ATTACHMENT 1

A. DESCRIPTION OF THE TECHNICAL SPECIFICATION AMENDMENT REQUEST

The proposed amendment changes the Shutdown Margin versus Cold Leg Temperature curve as set forth in Technical Specification (T.S.) 3.1.1.2. The change is to the Hot Zero Power endpoint. The change is from  $6.0\% \Delta\rho$  to  $6.5\% \Delta\rho$ .

FIGURE 3.1-5  
PART LENGTH CEA INSERTION LIMIT VS THERMAL POWER

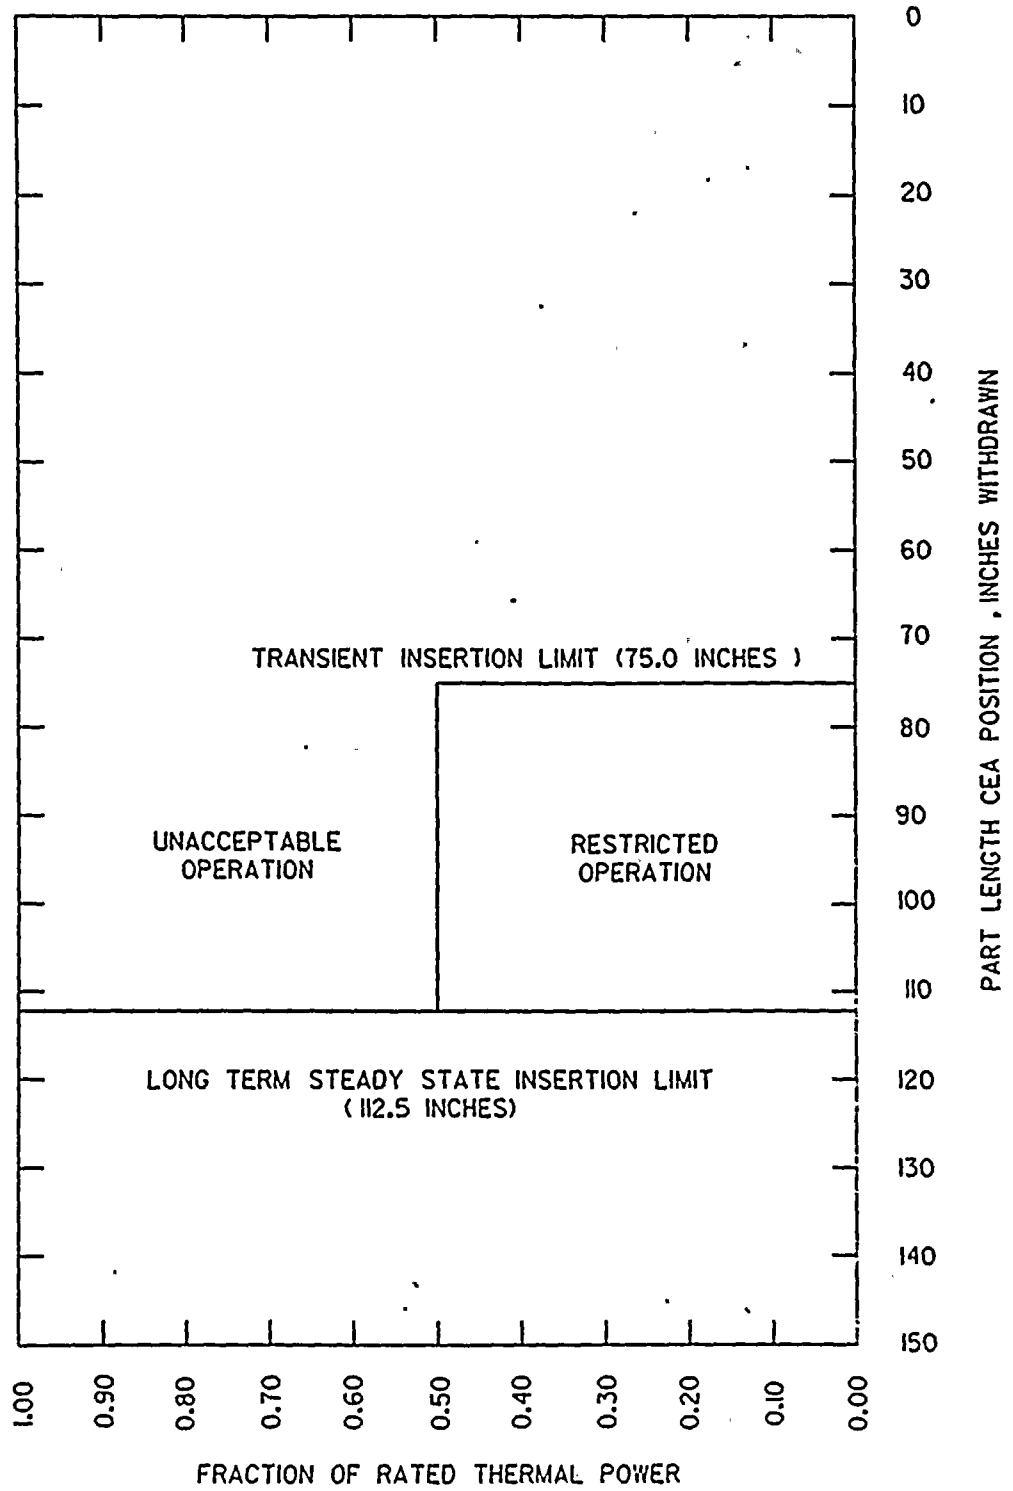
3.1.3.7 The part length CEA groups shall be limited to the insertion limits shown on Figure ~~3.1-3~~ with PLCEA insertion between the Long Term Steady State Insertion Limit and the Transient Insertion Limit restricted to:

FIGURE 3.1-3  
CEA INSERTION LIMITS VS THERMAL POWER  
(COLSS IN SERVICE)

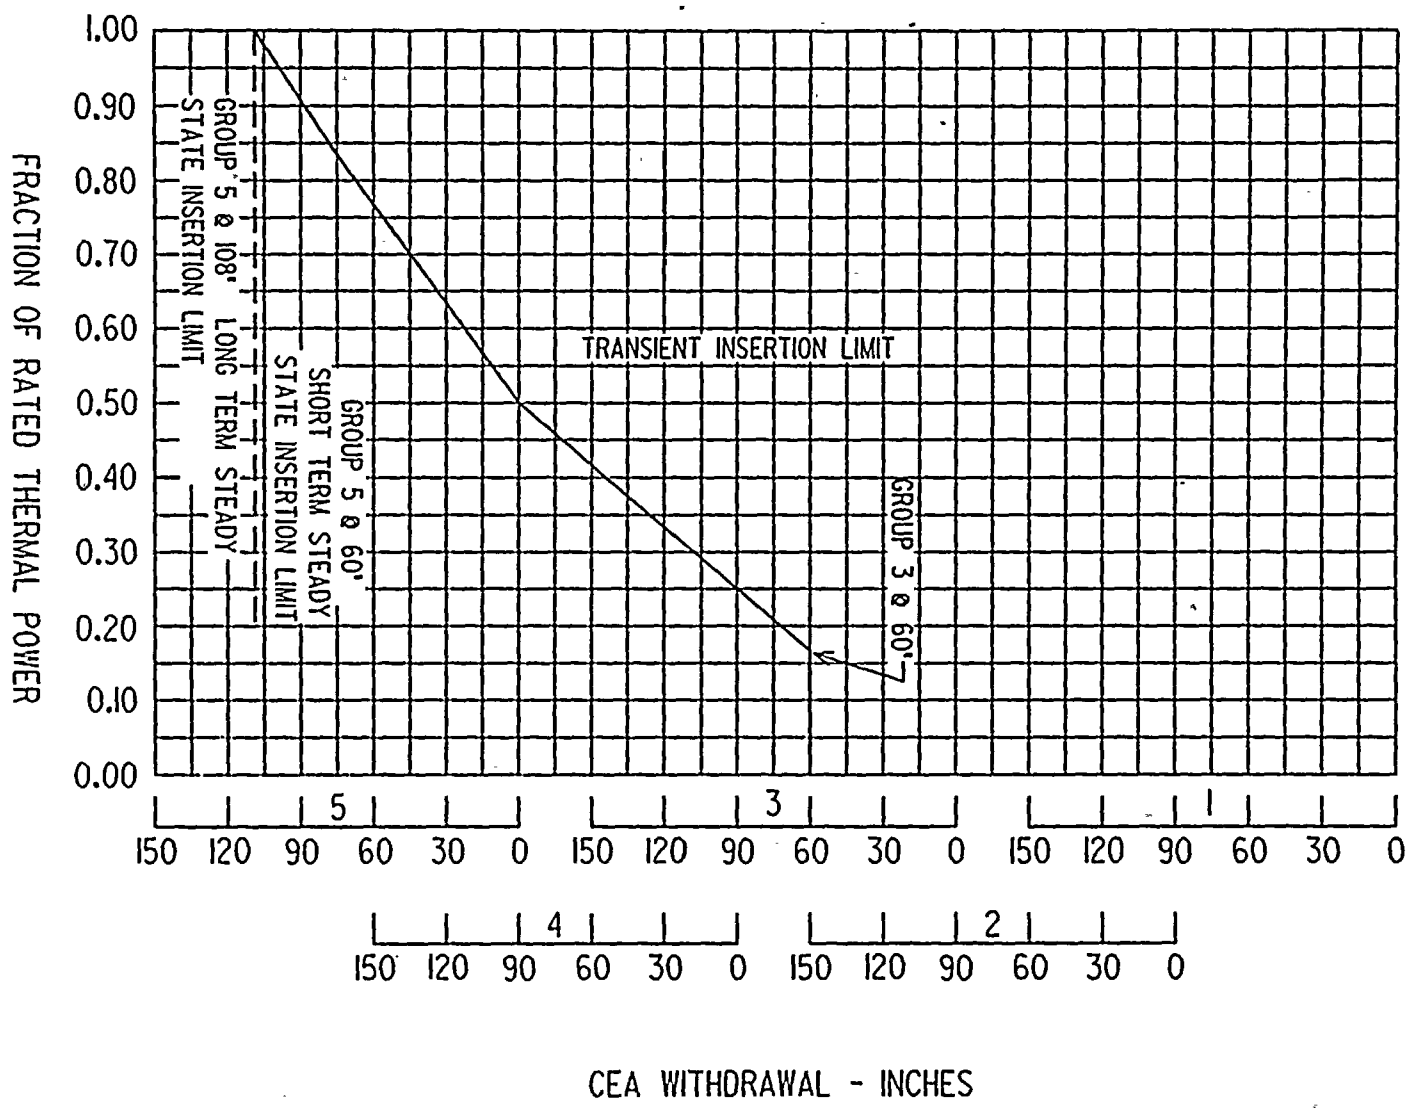
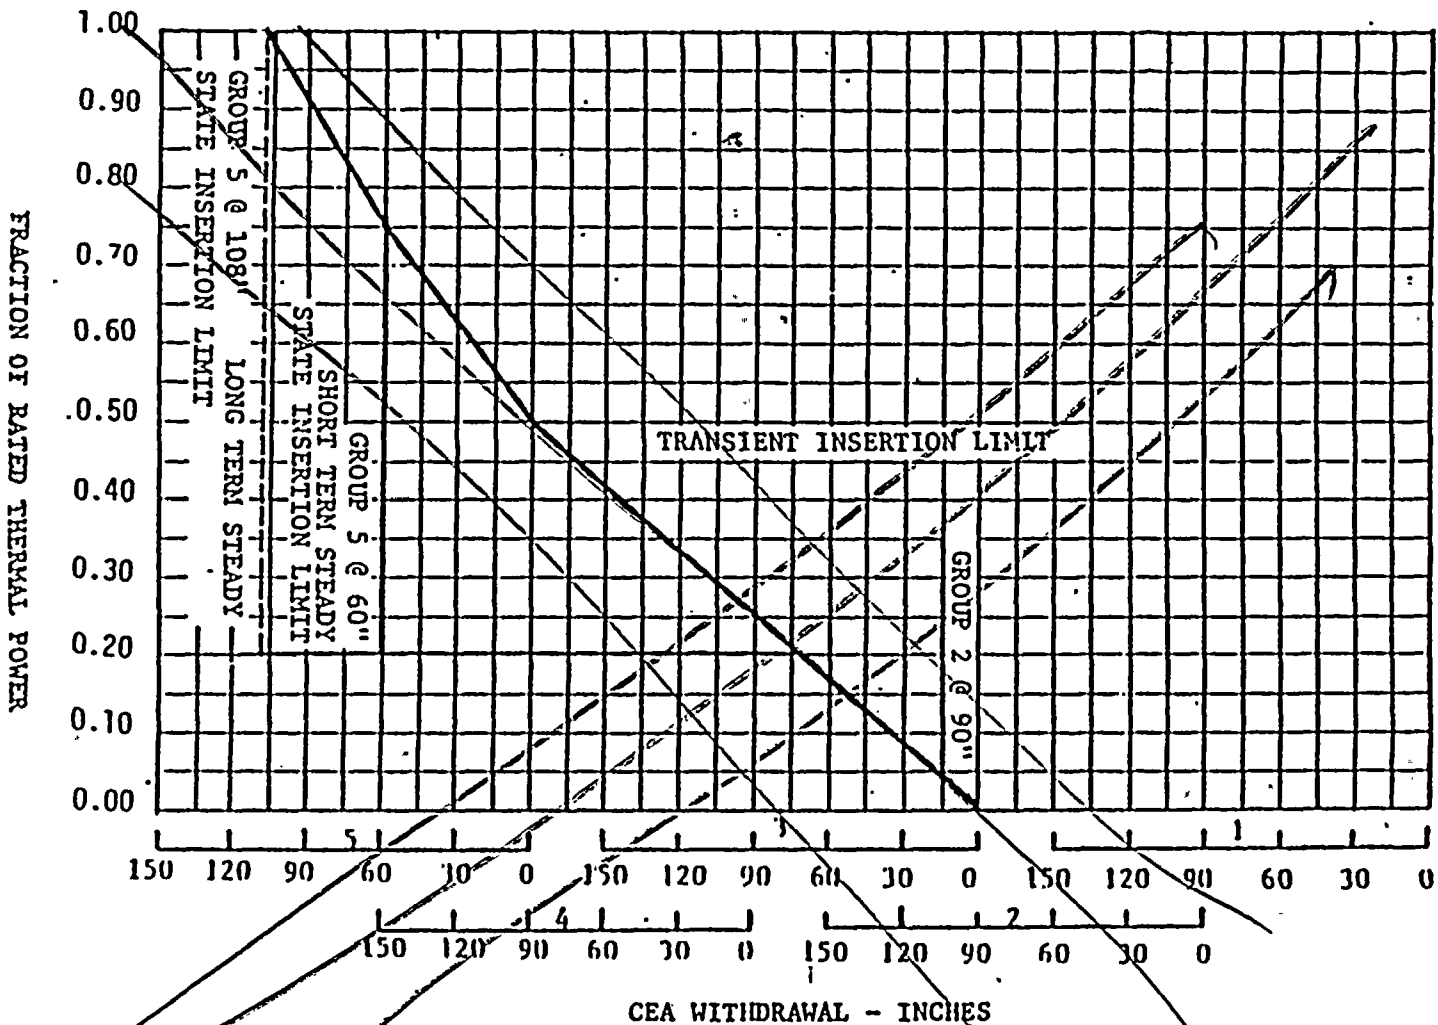
The proposed changes made to the CEA Insertion Limits are due to the change in the Cycle 2 core physics. Because of the change to the core, the worth of the CEAs has changed and as a result, the effects of the dropped and ejected CEA events change. To ensure that there is sufficient margin to mitigate such events, CEA insertion has to be restricted by the insertion limits set forth in the proposed T.S. 3.1.3.6.

The proposed change does not involve a significant increase in the probability or consequences of an accident previously evaluated because by restricting the insertion of the rods to Gp 3 60" withdrawn, margin is

FIGURE 3.2-1

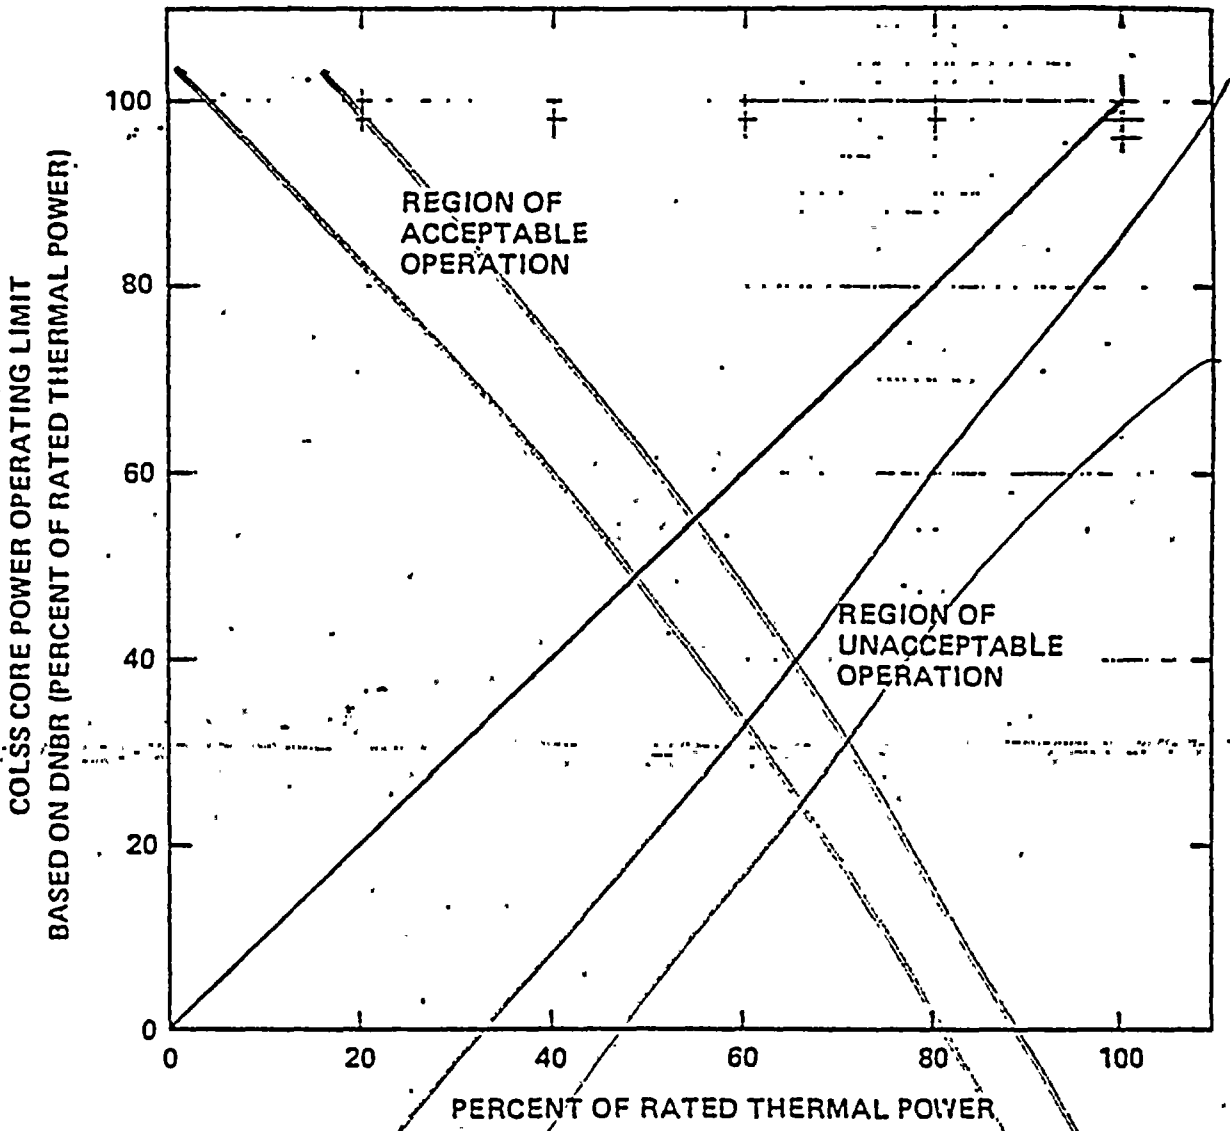
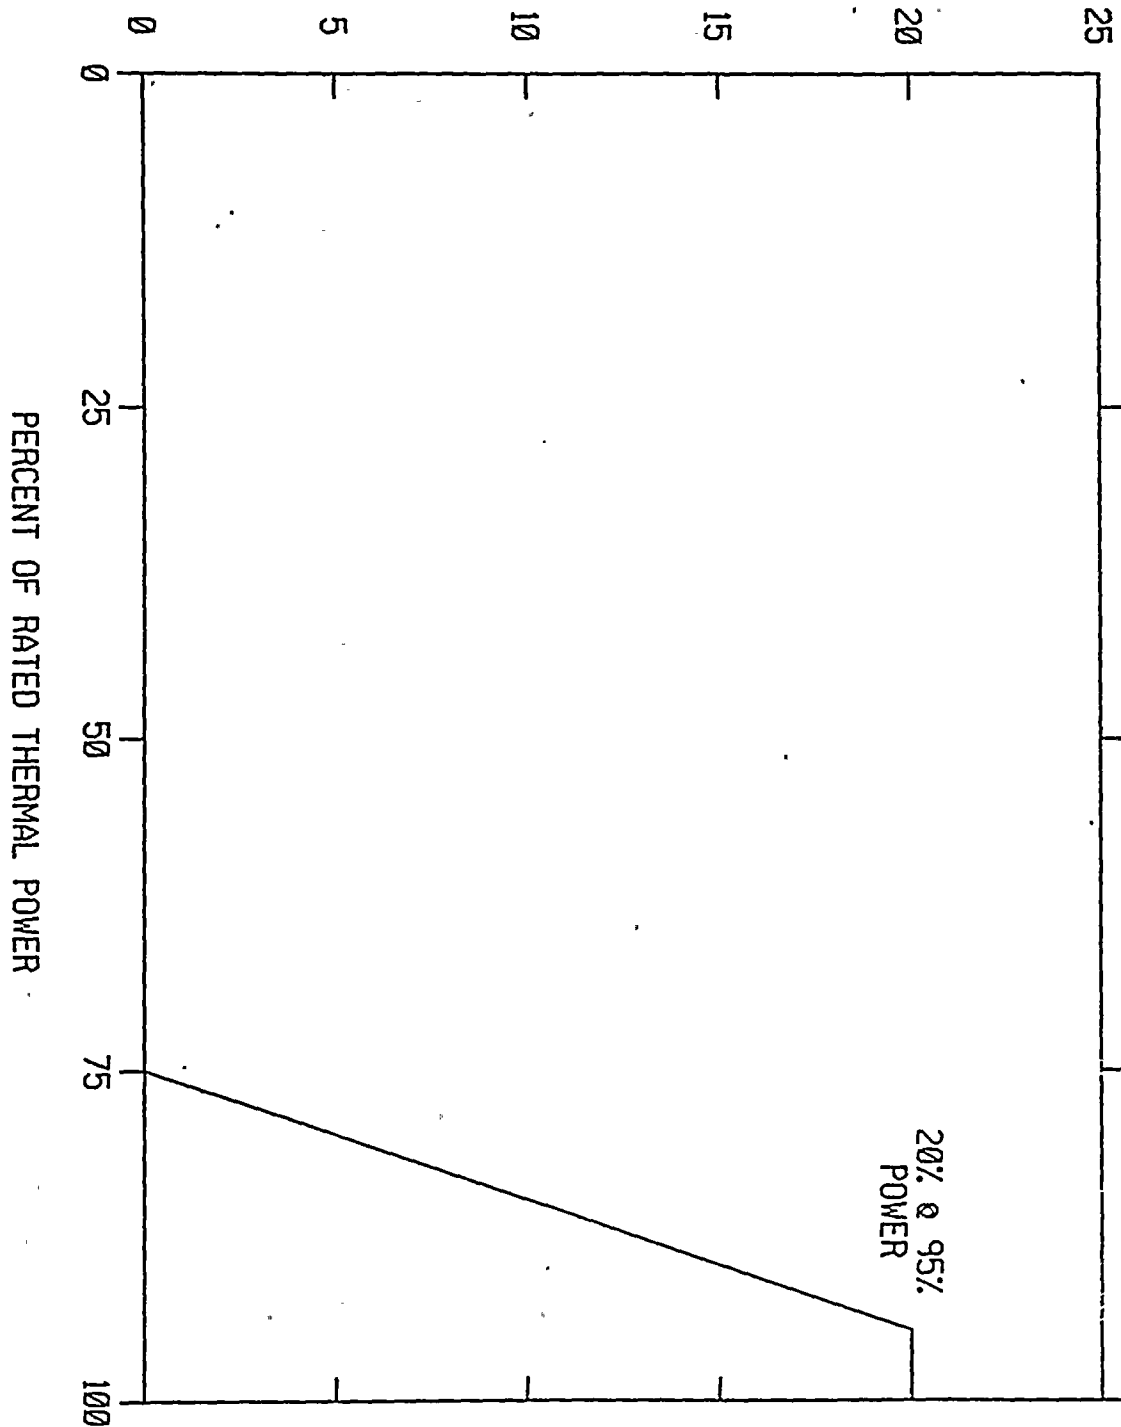
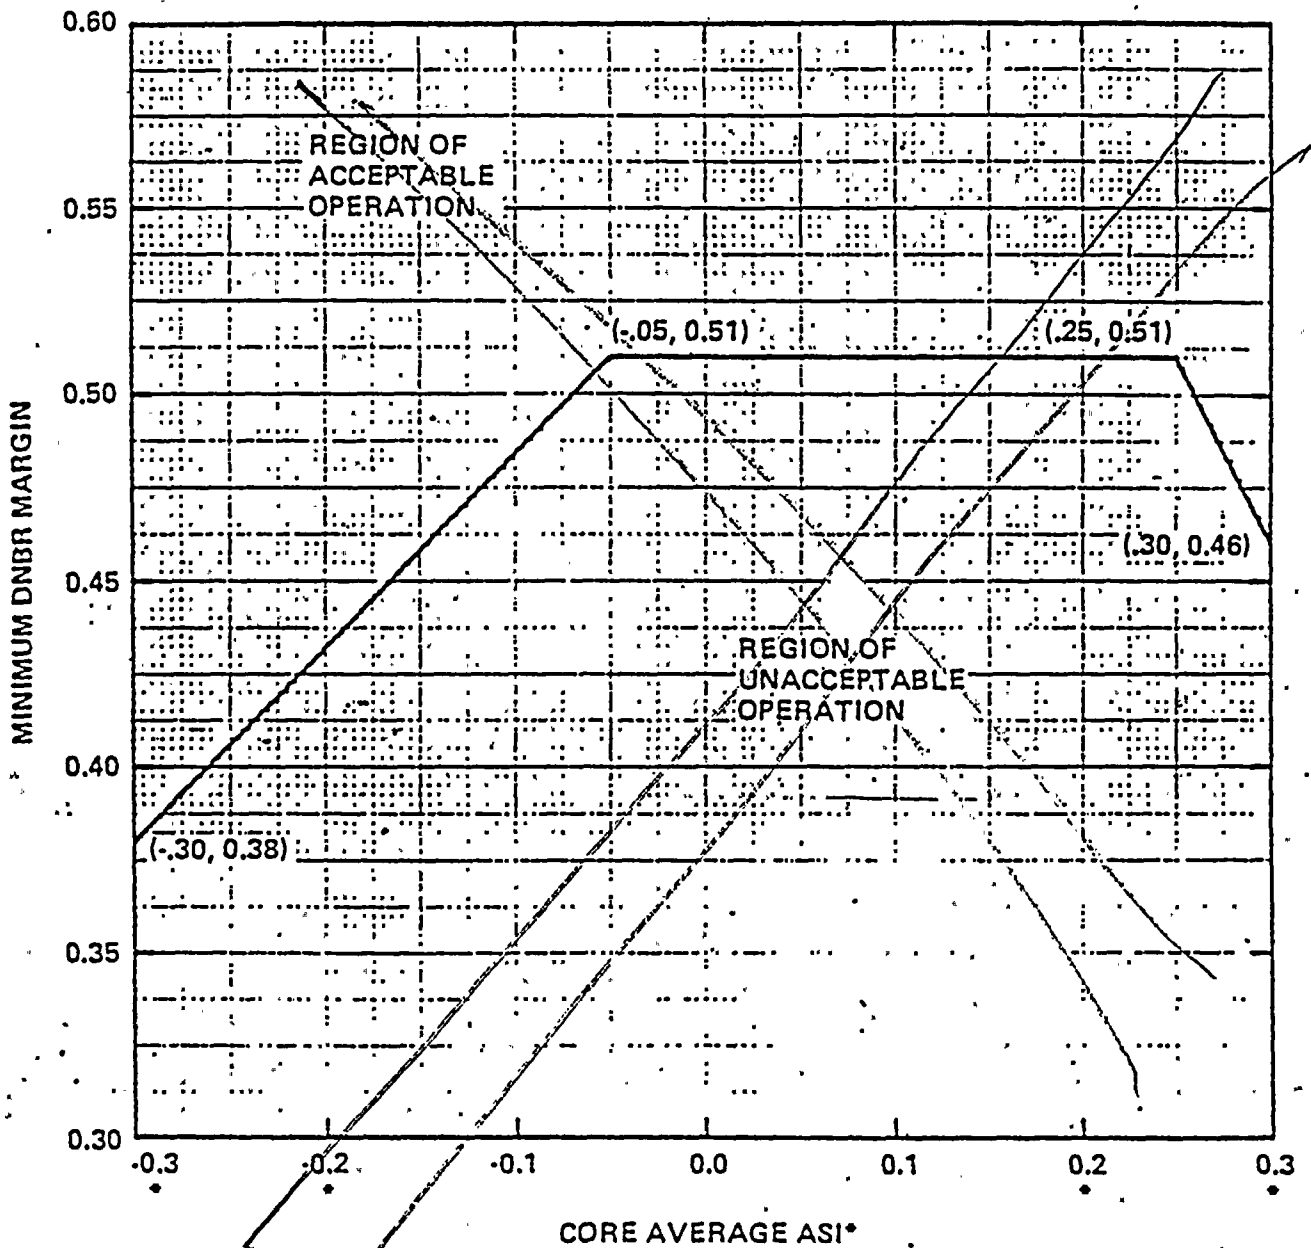
3.2.4 The DNBR margin shall be maintained by operating within the Region of Acceptable Operation of Figure 3.2-1 or 3.2-2, as applicable, or in accordance with the requirements of Action 6 of Table 3.3-1.
